SERVICE LETTER

No. 606A

August 23, 1972

Fuel System Inspection and Modification

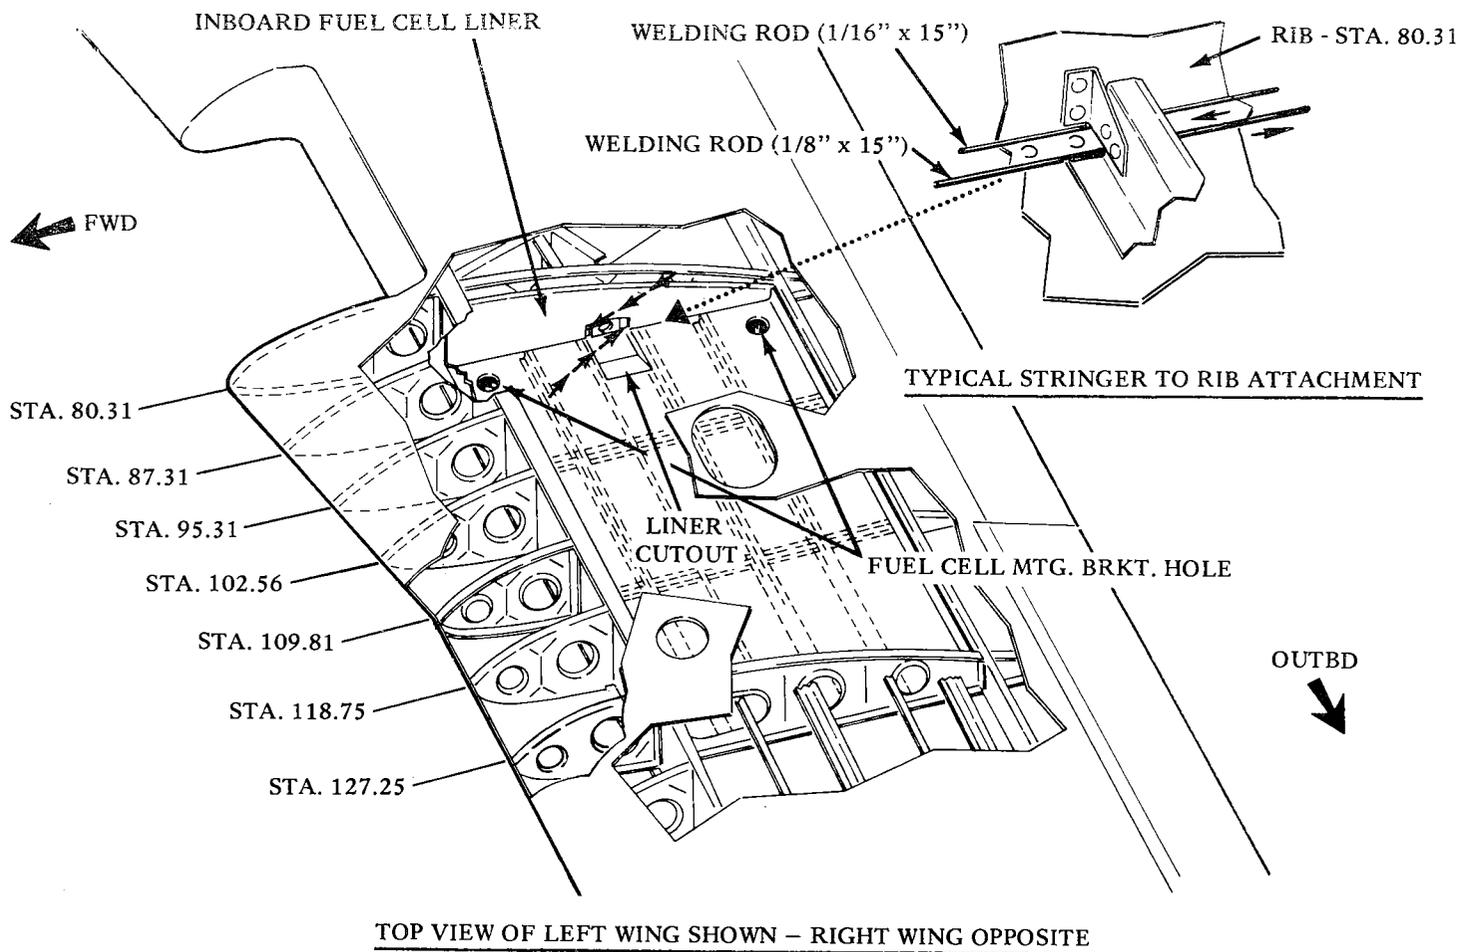
- G. Modify the fuel cell wing cavity drains by installing Wing Panel Vent Drain Installation Kit, Piper Part No. 760 578 (reference Material Required, below); reference attached sketch "B."

- E. Modify the fuel cell wing cavity drains by installing Wing Panel Vent Drain Installation Kit, Piper Part No. 760 578 (reference Material Required, below); reference attached sketch "B."

● INSTRUCTIONS FOR RESEALING INBOARD FUEL CELL WING CAVITY AREA

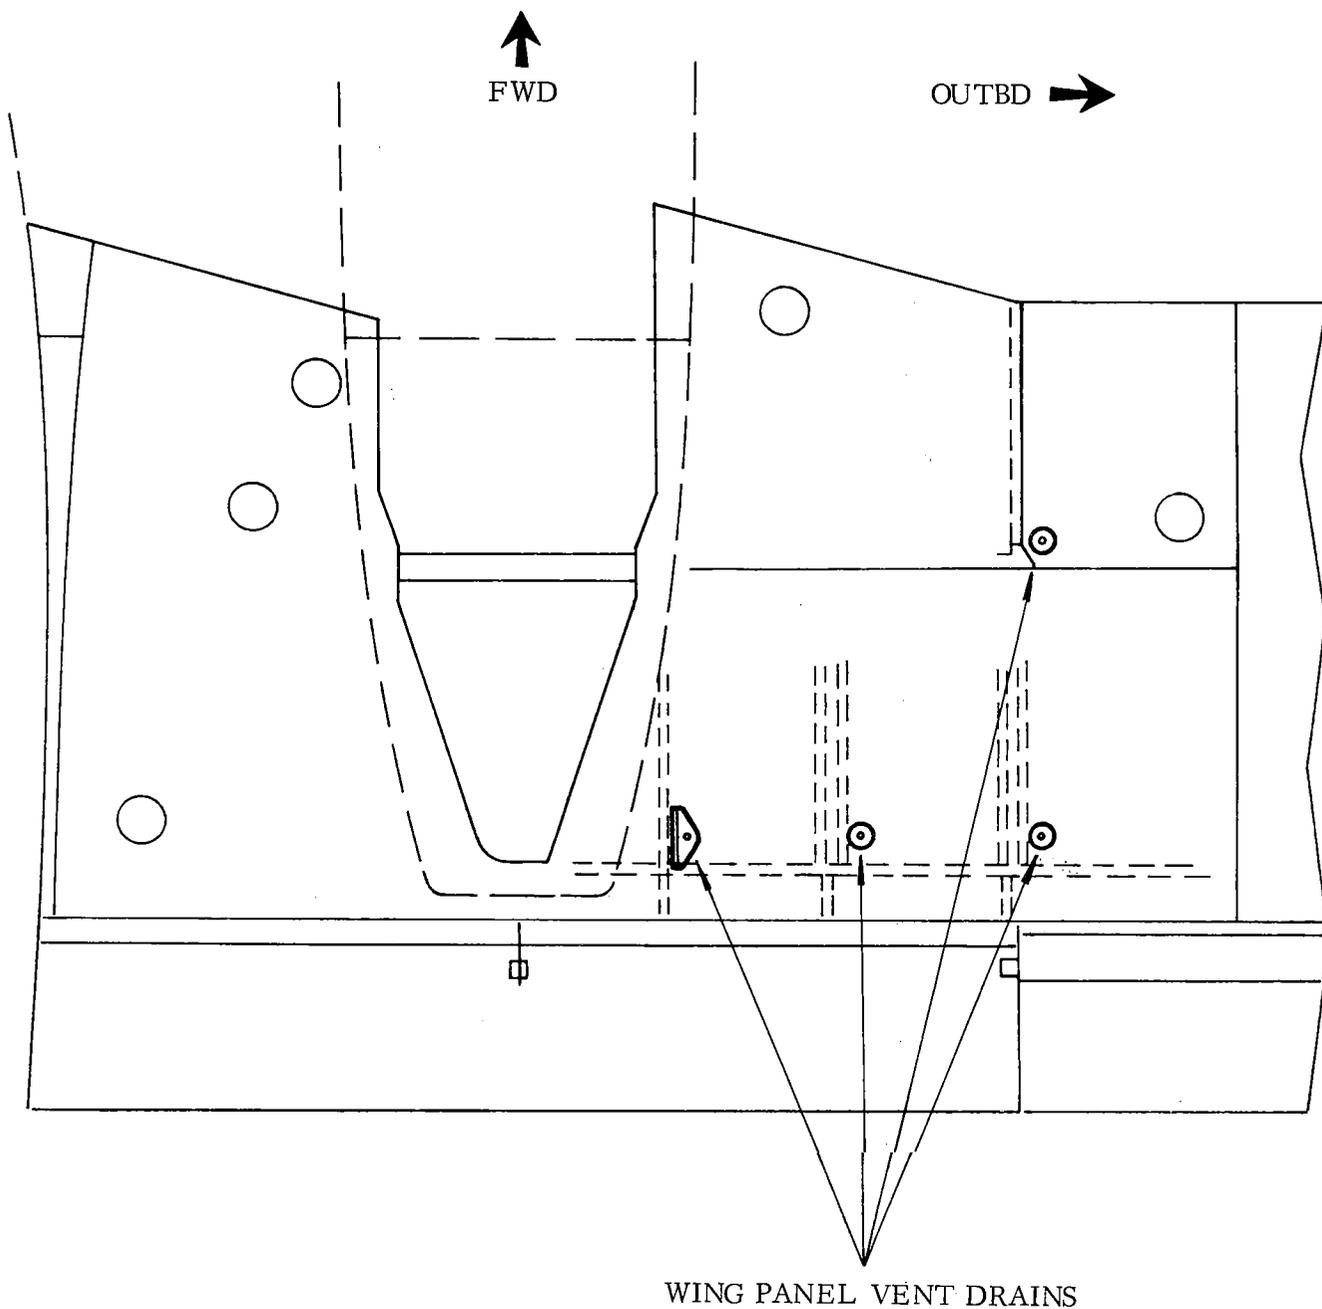
3. To facilitate flow-thru of sloshing compound along bottom rib flange at Sta. 80.31 and bottom skin stringer to rib attachment areas (see detail), proceed as follows:

- a. Insert a 1/8" welding rod (pointed on end) into fuel cell liner cutout (fuel cell outlet area), routing rod behind inboard fuel cell liner and along bottom rib outside flange using a push-pull motion which will "drill" hole thru existing sealant. This procedure shall apply to all four stringer to rib attachment points. Remove rod from wing cavity.

4. Insert two 1/16" welding rods into fuel cell liner cutout, one toward front spar and one toward rear spar, routing rods behind inboard fuel cell liner and along bottom inside radius of rib flange. (See detail). Leave rods in this position. They will be removed later.

5. Cover hole in rib through which the fuel cell's outlet nipple fits, and cover all drain holes in bottom of wing skin between Stations 80.31 and 127.25 with masking tape.
